Recreation Precinct Masterplan 2021 - Sporting Clubs Feedback	Respondent
Are you able to send me a copy of the revised Master Plan that was presented to council please?	
SK: The revised Masterplan that was proposed can be found under item 10.1.10 of the February Ordinary Council Meeting. Please find below the link to the minutes for your reference. https://www.cottesloe.wa.gov.au/council-meetings/ordinary-council-meeting/23-february-2021-ordinary-council-meeting/281	Sam Diamond President Cottesloe Rugby Union Football Club
	20 April 2021
	TRIM Ref: D21/20051
Can you please provide comment as to the type and extent of fence to be installed to mitigate against golf balls and comment on the works proposed in extending the formalised carpark adjacent to Harvey Field?	Sam Diamond President
SK: I would say that the height will be designed in consultation with Seaview Golf Club to determine the type of club that will be used for the tee off and subsequent shots. The formalised carpark along Broome Street will be extended to the north, constructed in asphalt with marked	Cottesloe Rugby Union Football Club

COTTESLOE OVAL

OPTION 1

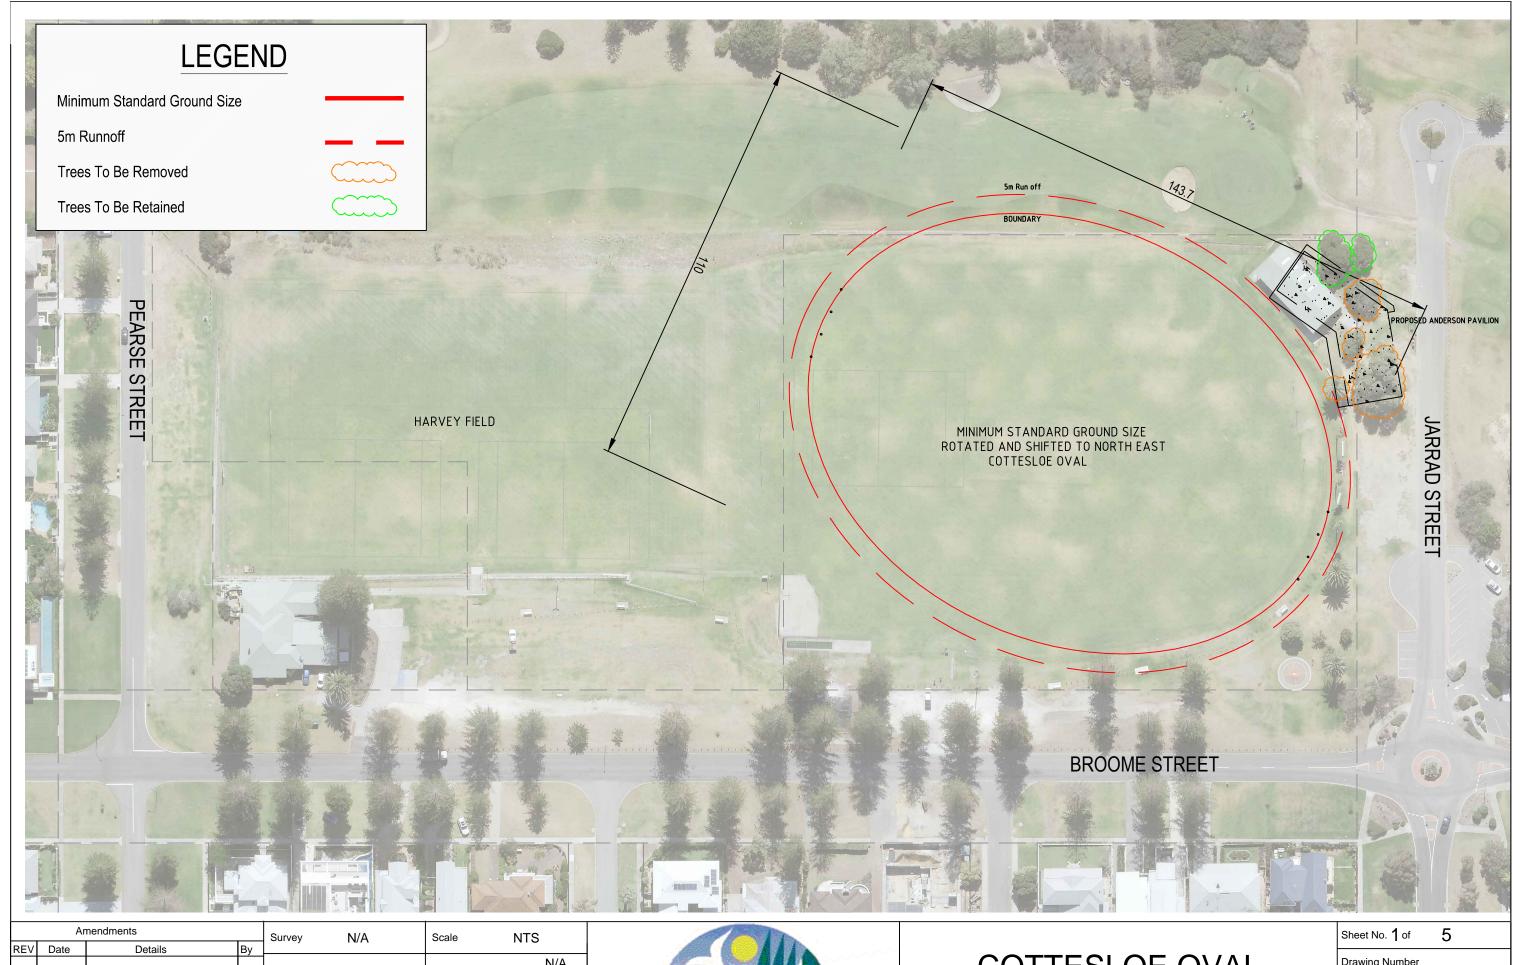
up bays.	27 April 2021 TRIM Ref: D21/18692 & D21/18890
We are in favour of the re-positioning of Cottesloe Oval to increase the length and width of the playing field, whilst hopefully reducing the impact of stray golf balls.	Hudson Wheeler
However, it's imperative that our number one focus is the new clubrooms. I understand re-positioning the oval affects the final positioning of the new clubrooms.	President Cottesloe Football Club
I'd just like to have a better understanding of the cost associating with the re-positioning of the oval, and if there are any financial implications on the clubrooms at all.	27 April 2021 TRIM Ref: D21/18698
SK: We have explored all options of repositioning the field (rotate and lateral shifts) to accommodate a playing surface that is more in line with standards.

Recreation Precinct Masterplan 2021 - Sporting Clubs Feedback	Respondent
Whilst all these solutions do not appear to affect the new Anderson Pavilion, it does however, results in an impact on the embankment to the east (including trees) and requires a fill to the west. The larger fields closer to the MCG type standards will have an impact on the golf course. These field expansion options come at a significant cost that could possibly make the Harvey Field Precinct project unaffordable. Fencing will be considered as part of the concept to protect the existing field and new pavilion from stray golf balls. Notwithstanding the above, we will put your comments forward to Council for their consideration.	
Please also make it aware that the MCG is unique, and not the standard Australian Football Oval size. It's definitely much wider (Almost as long as it is straight). I wouldn't recommend attempting to replicate the MCGs dimensions.	Hudson Wheeler President Cottesloe Football Club (Roosters)

FOOTPRINT SIZE
WIDENED TO MINIMUM AFL STANDARD
OPTION 2

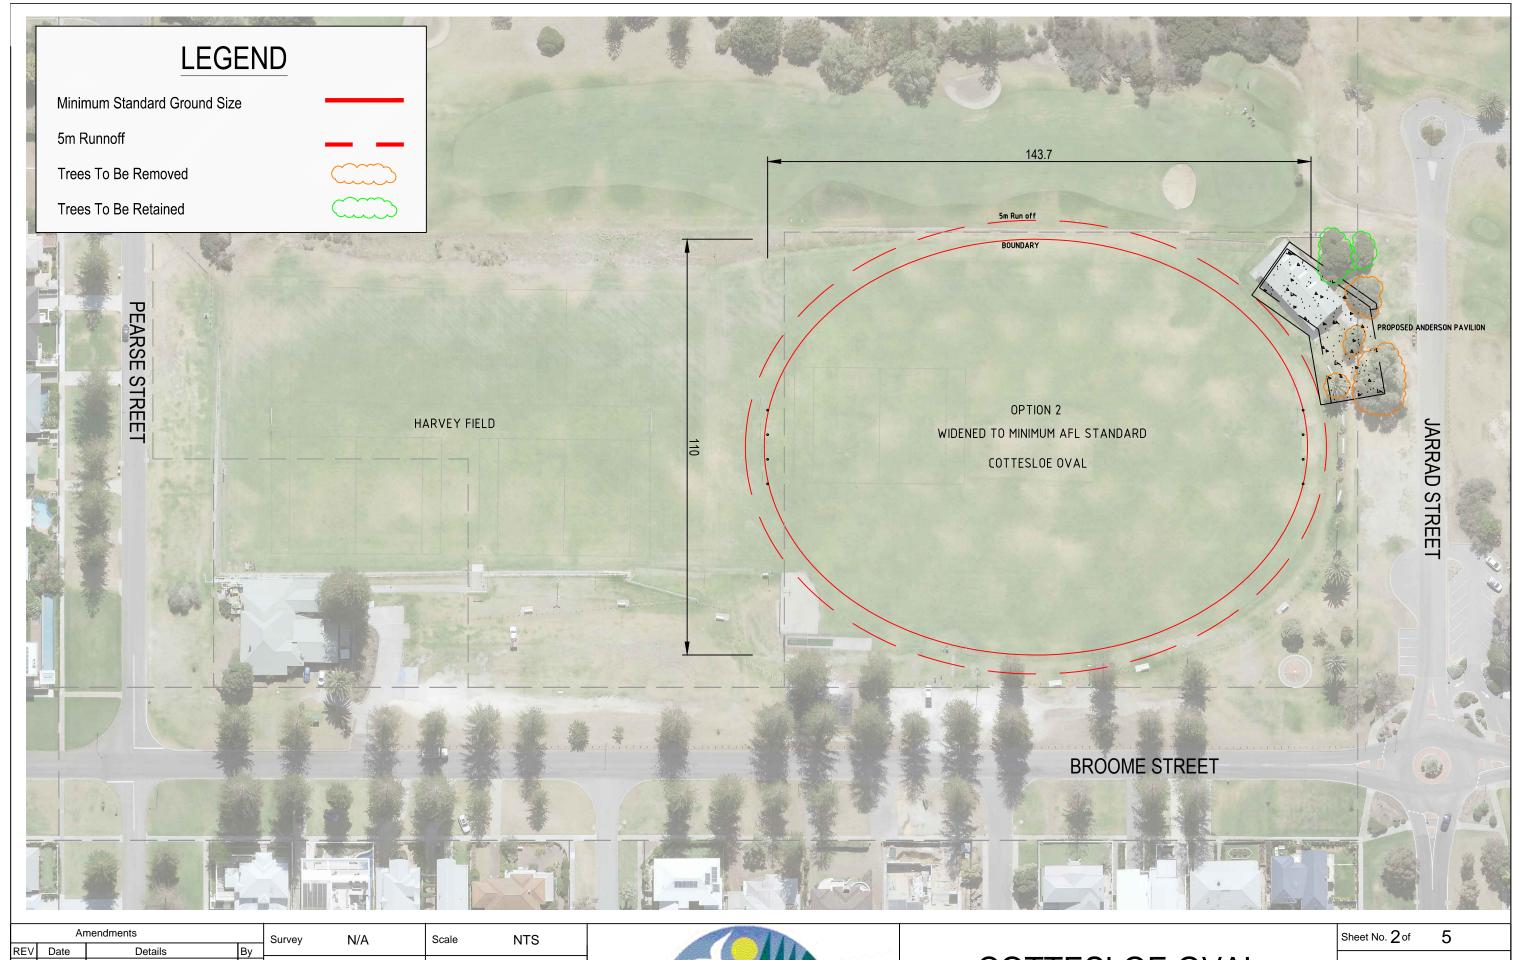
From memory the width of our ground would only need to increase by 2m - 3m to meet the minimum width required. However, increasing the length of the ground may be more achievable even if it's only increased around 10m - 15m. Which may make it more achievable?	27 April 2021 TRIM Ref: D21/18707
SK: Given that we are refurbishing the field, the 2 to 3 m extension would need to be accompanied with a 5 metre run off zone, effectively making the widening an additional 8 metres.	
This extra bit makes the design tricky in keeping everything on the existing formation.	
I note your comments regarding the MCG type design.	
Thanks for the opportunity to comment on the Harvey Fields Recreation Precinct Masterplan. Whilst we are in general agreement with the plan, we would like to see a more being done to mitigate the	Paul Quinlivan President Cottesloe Magpies
